RECEIPT DATE: 3/15/23 **ONSITE SEWAGE DISPOSAL SYSTEM** P 574032
 APPROVAL DATE: 5/9/23 **PERMIT: CONSTRUCTION** A _____
 PROPERTY ADDRESS: 18406 Hidden Creek Ct.
 SUBDIVISION: Windsor Forest Knolls LOT: 1 TAX ID: _____
 CONTRACTOR: Farm & Home Excavation Inc EMAIL: _____
 CONTRACTOR ADDRESS: _____ PHONE: 410.442.2139
 PROPERTY OWNER: Senshine MD, LP EMAIL: _____
 OWNER ADDRESS: 227 Granite Run Dr. SE 100 Lancaster PA PHONE: 717.464.9060
 SEPTIC TANK SIZE (GALLONS): 2,000 TANK MANUFACTURER: MBI
 PUMP MODEL: _____ PUMP SIZE _____ PUMP TANK CAPACITY: _____

PROJECT:	WINDSOR FOREST KNOLLS LOT 1		
LOCATION:	TAX MAP: 6 - GRID: 16 - PARCEL: 57 18406 HIDDEN CREEK WAY, TAX ID# 04-373162 ELECTION DISTRICT NO. 4 - HOWARD COUNTY, MARYLAND		
TITLE:	ONSITE SEWAGE DISPOSAL PLAN		
HOUSE TYPE:	CUSTOM - KEYSTONE HOMES		
DATE:	APRIL, 2023	PROJECT NO.	2986
SCALE:	AS SHOWN	DRAWING	2 OF 2

PROJECT:		WINDSOR FOREST KNOLLS LOT 1	
LOCATION:		TAX MAP: 6 - GRID: 16 - PARCEL: 57 18406 HIDDEN CREEK WAY, TAX ID# 04-373162 ELECTION DISTRICT NO. 4 - HOWARD COUNTY, MARYLAND	
TITLE:		REVISED ONSITE SEWAGE DISPOSAL PLAN	
HOUSE TYPE:		CUSTOM - KEYSTONE HOMES	
DATE:	APRIL, 2023	PROJECT NO.	2986
SCALE:	AS SHOWN	DRAWIN

LOT 1 SEPTIC PROFILE
SCALE: 1"=50' HORIZ., 1"=5' VERT.

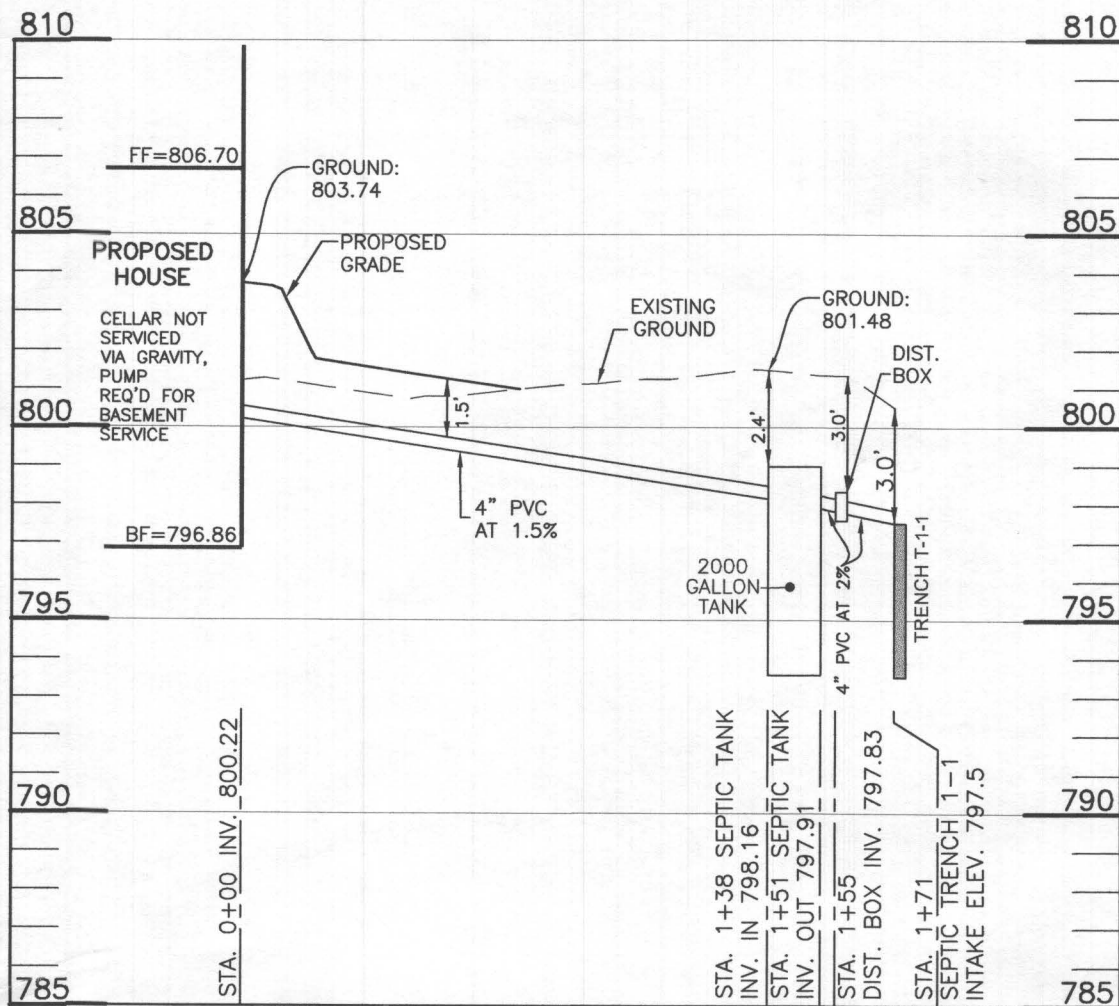
email
 Show on plans →
 John Carney/Alice
KeyStone
 cc: Bill -
 Utilities / above → overhead

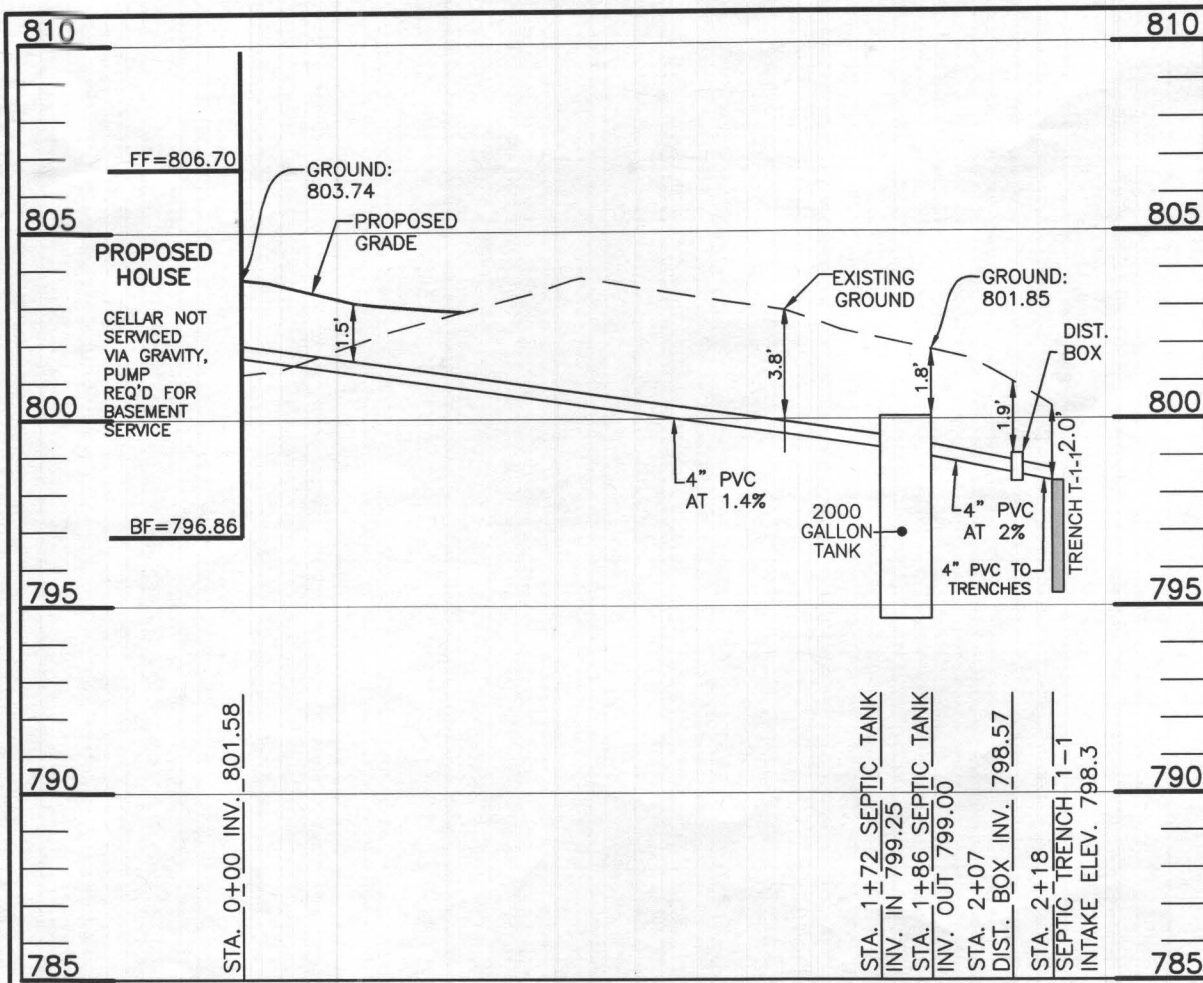
10 dig
8 ft
from pole
